From: Stockdale, Erik
Sent: Friday, July 27, 2001 11:30 AM
To: Kenny, Ann
Subject: Additional Mitigation - DELIBERATIVE - DO NOT DISCLOSE

Mitigation for Temporary Impacts SeaTac 3rd Runway

Attachment A
Wetland A17 Complex

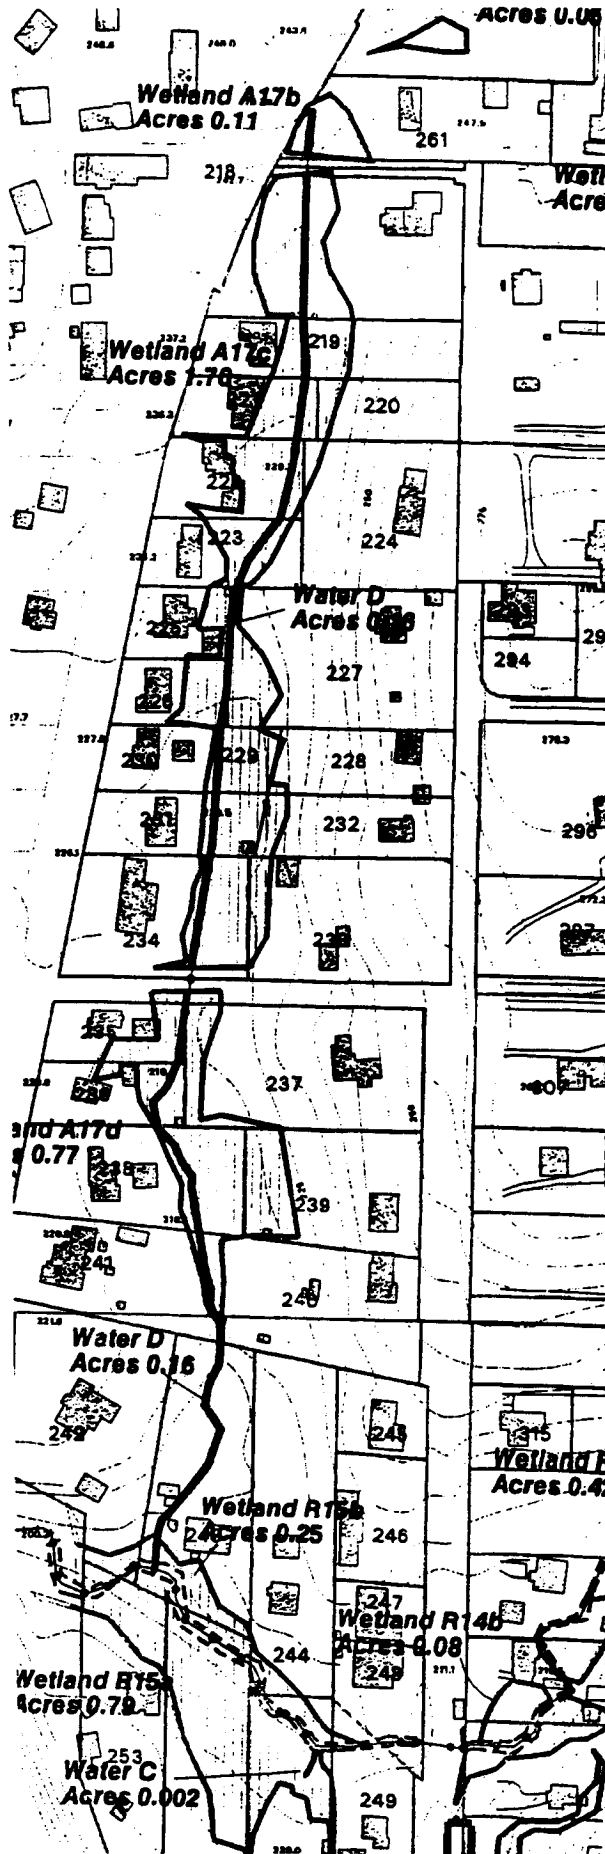
- The wetland/riparian zone comprised of wetland A17b/c/d and water D will be added to the wetland and buffer restoration/enhancement on Miller Creek. This area is depicted in Attachment A titled "Wetland A17 complex". A 100-foot buffer will be placed to envelop this system. The wetlands total 2.64 acres and "Water D" totals 0.16 acres for a combined total of 2.80 acres (not including the buffer). The buffer will be averaged, similar to the buffer on Miller Creek.

- The submittal will evaluate the feasibility of improving the hydrologic connection of wetland A17 complex to Miller Creek via "Water D".
- Homes, driveways, concrete, fill, septic systems and other unsuitable material will be removed from the wetland complex, similar to the treatment protocol for the Miller Creek restoration.

- The submittal will develop a buffer restoration and revegetation plan for this area, similar to the treatment protocol for Miller Creek. This will include the removal of invasive species, and replanting of appropriate native species.

- The submittal will evaluate the potential for wetland restoration and enhancement within this new mitigation zone.
- The buffer will be joined with the buffer on Miller Creek to the south.
